L A N D M A R K S
P R E S E R V A T I O N
C O M M I S S I O N

S T A F F R E P O R T

2113 Kittredge Street – California Theater

Preliminary review of Structural Alteration Permit (#LMSAP2022-0011) to demolish the California Theater building while retaining and rehabilitating the primary façade, and to incorporate the façade into the construction of a new 18-story, mixed-use building featuring an approximately 24,000-sq. ft. performance venue and 211 dwelling units in the Downtown – APN 57-2030-9

1 PROPOSED THEATER FACADE MODIFICATIONS
G005 1/8" = 1'-0"

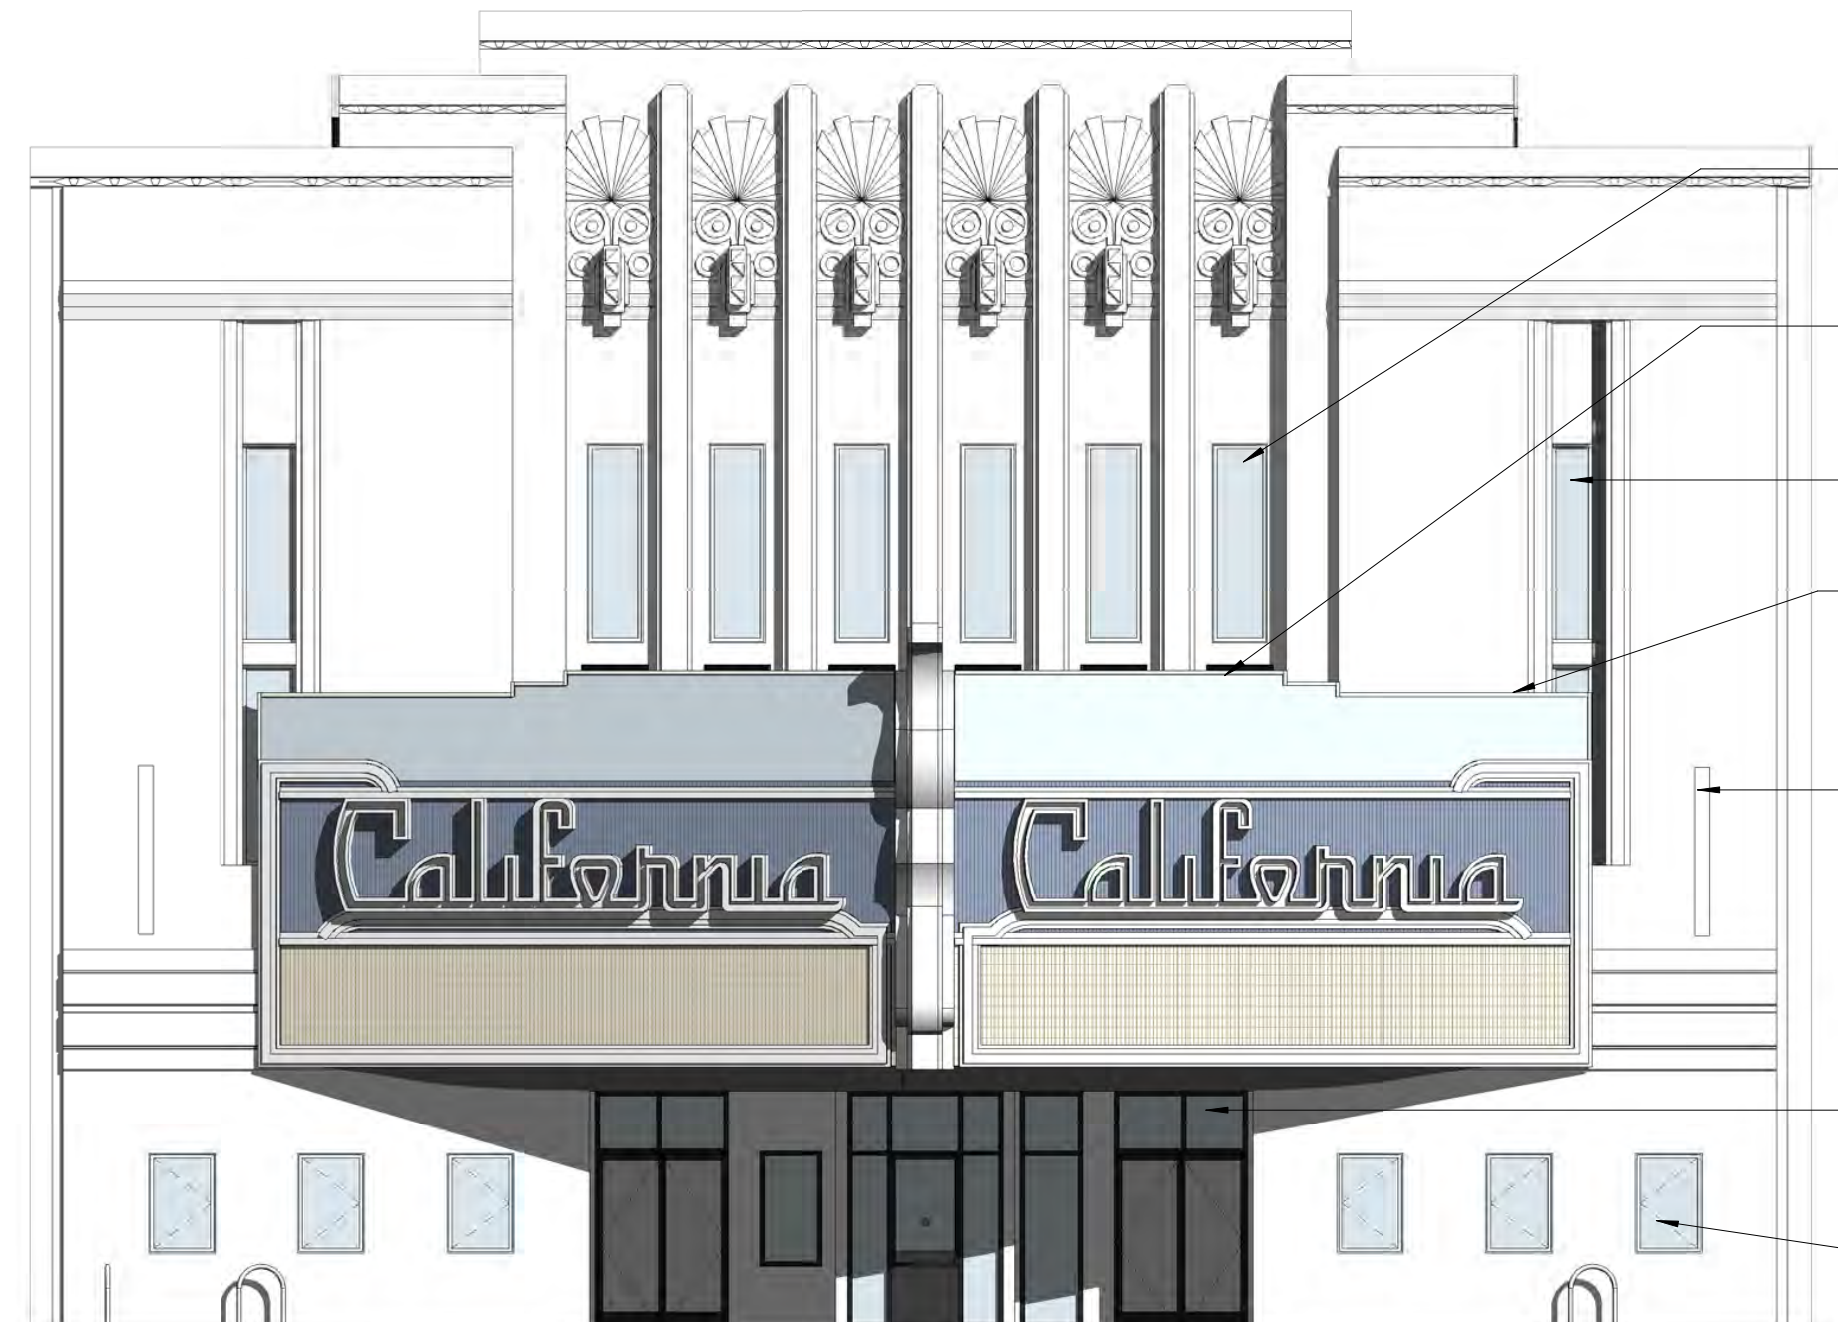
While the proposed tower would be approximately three-times taller than the retained Art Deco building façade, the historic façade would feature prominently at the street level. Visual prominence could be further ensured by employing deeper massing step-backs and/or reducing the proposed height or bulk of the tower. While an earlier iteration of the proposal was under review, staff suggested a greater building step-back at the proposed fifth floor; the applicant responded with a design modification that increased the step-back from 5 to 10 feet but also increased the proposed height of the new building.

Incorporate a simple, recessed, small-scale hyphen to physically separate the old and new volumes or setting the addition back from the wall plane(s) of the historic building.
